Attached please find additional correspondence that THINC requests be included with the public comments relating to PL-08-00370, Treasure Hill Conditional Use Application, Creole Gulch and Town Lift Mid-station Sites. I have also attached a copy of the slide presentation I used during the August 10, 2016 Planning Commission meeting, along with the slides that were presented by John Stafsholt at the same meeting. We request that both slide presentations be included with the public comments. Please let me know if you have any difficulty opening the attached files. Thank you.

Re: Treasure Hill Conditional Use Permit Application

I write on behalf of THINC, Inc., a non-profit organization comprised of hundreds of Park City residents, business owners, and home owners. This letter is intended to supplement and clarify my public comments at the August 10, 2016 meeting of the Planning Commission with respect to Project Number PL-08-00370, Treasure Hill Conditional Use Permit Application, Creole Gulch and Town Lift Mid-station Sites.

Mid-Station site: Most Visible from Main St.
MPE Section drawing S.2 through Bldg 1B
Excavations of 80'- 140' MAX

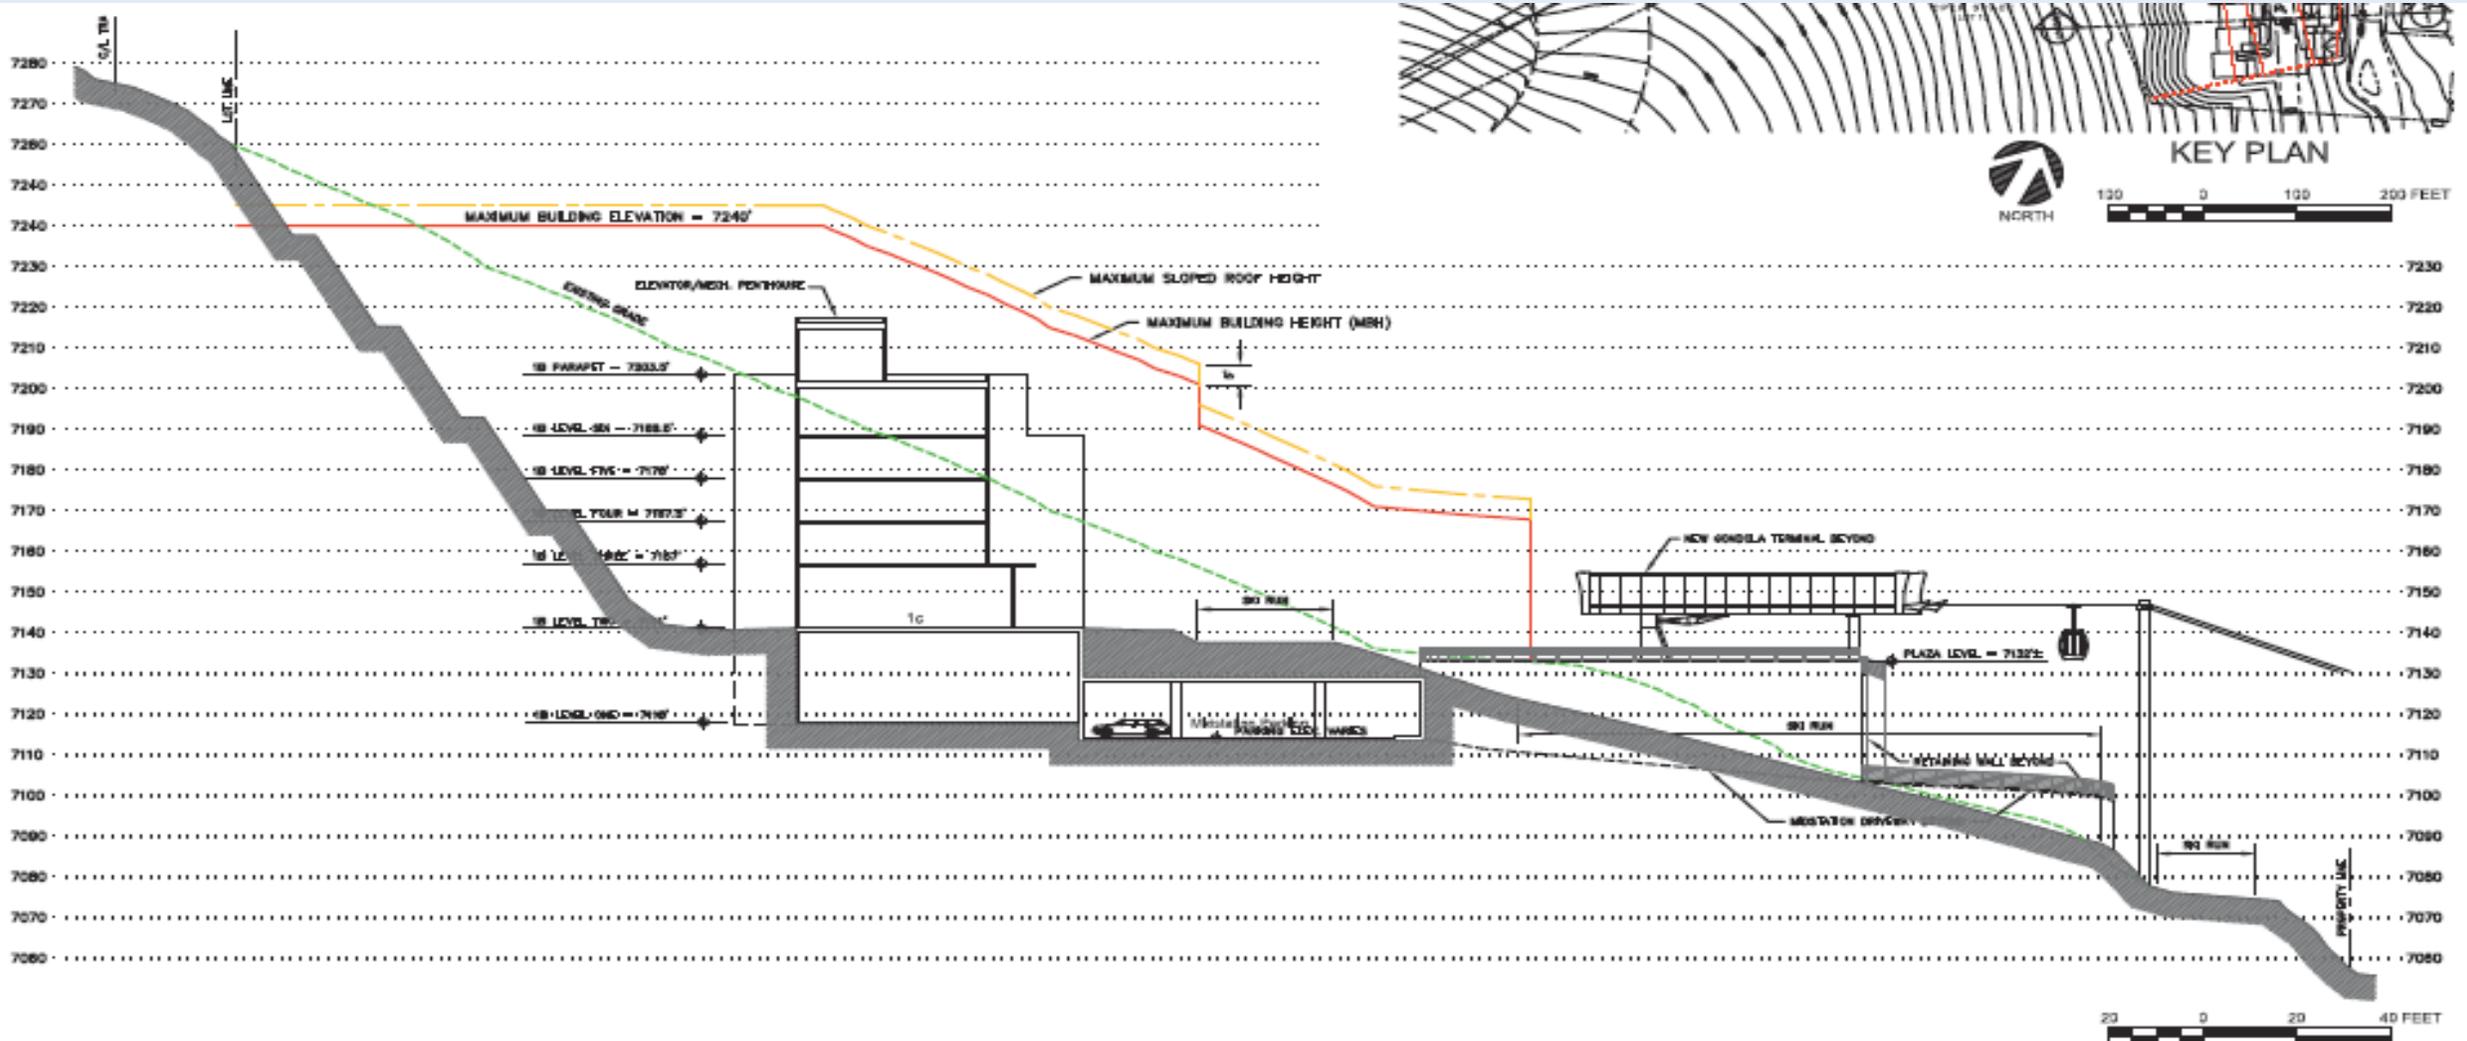
Buidings underground

MPE Section drawing S.8 through Building 4B Excavations of 110'- 145' MAX

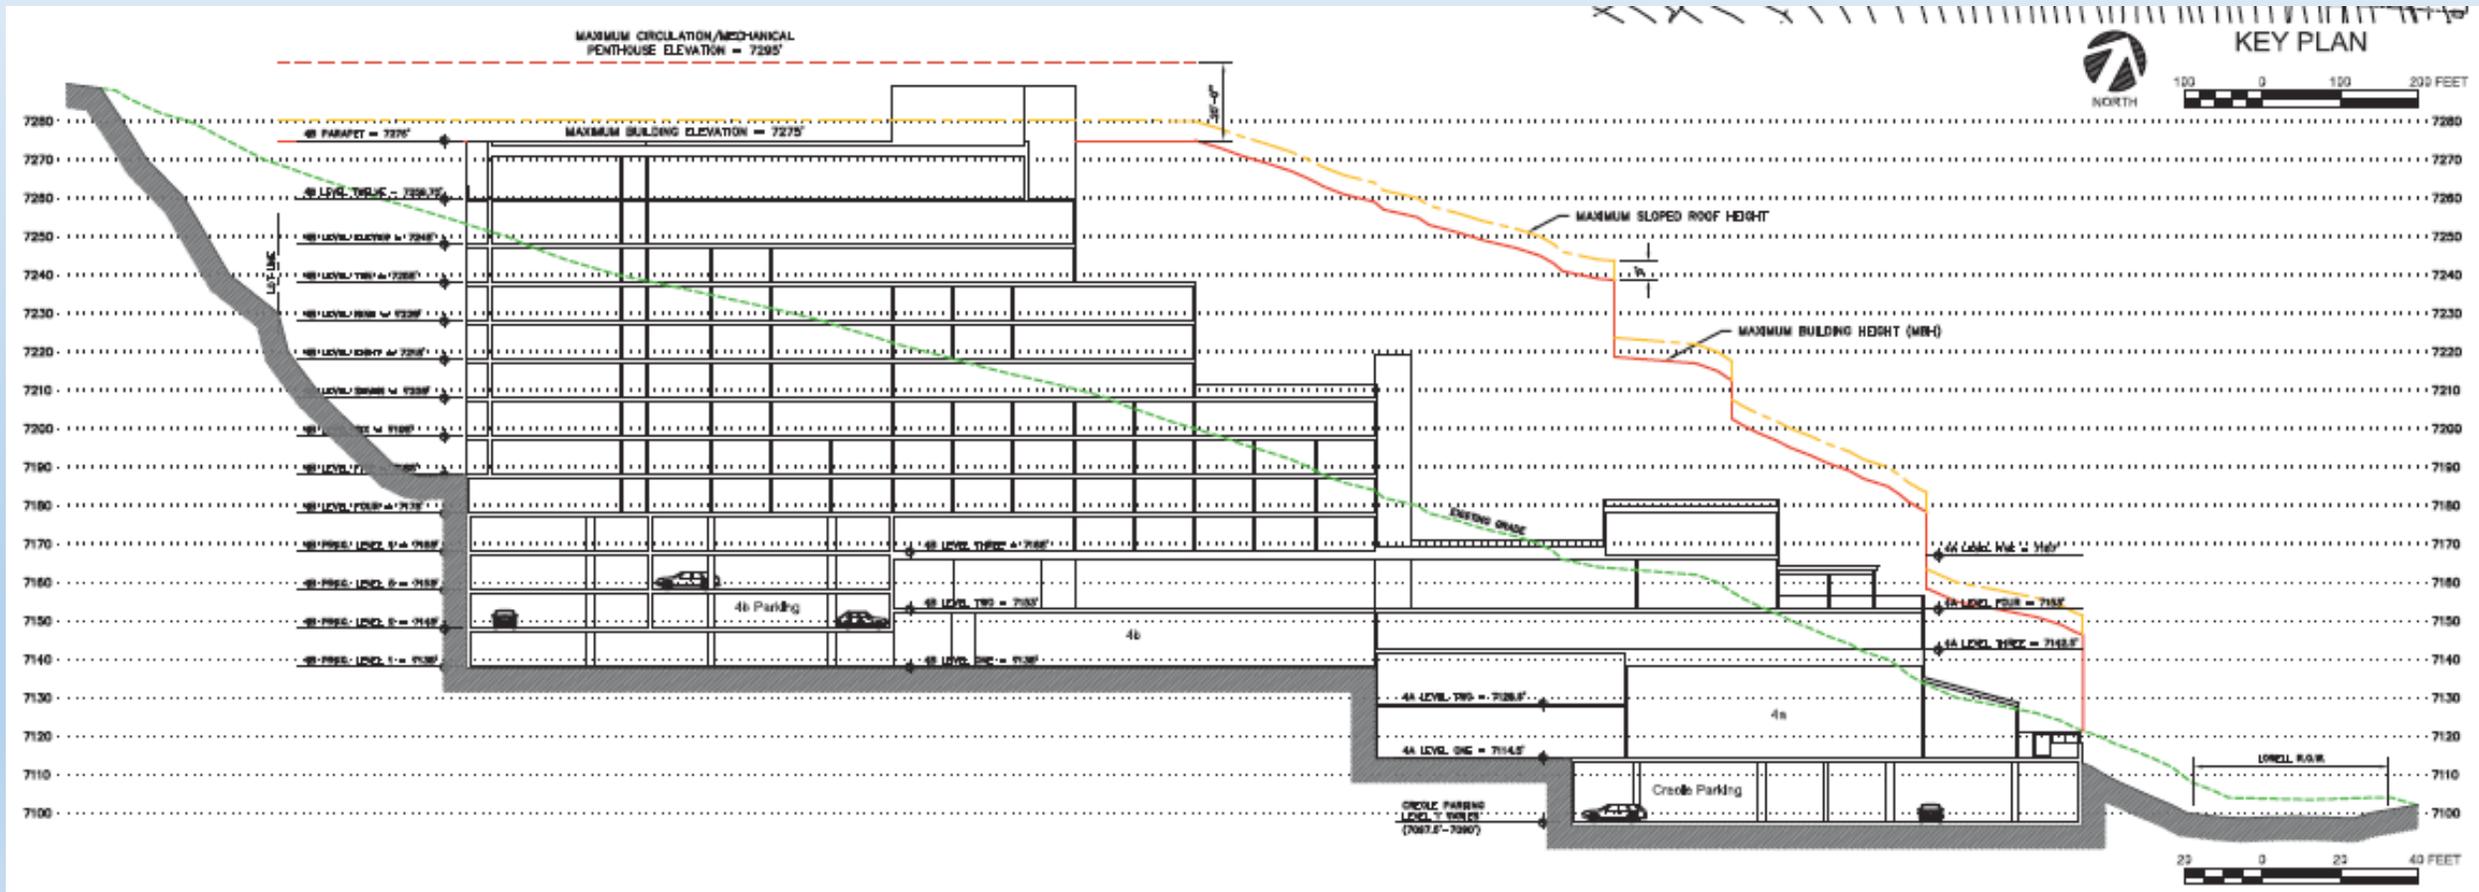
NOTE: what was envisioned in 1985 approval is between the green & red lines
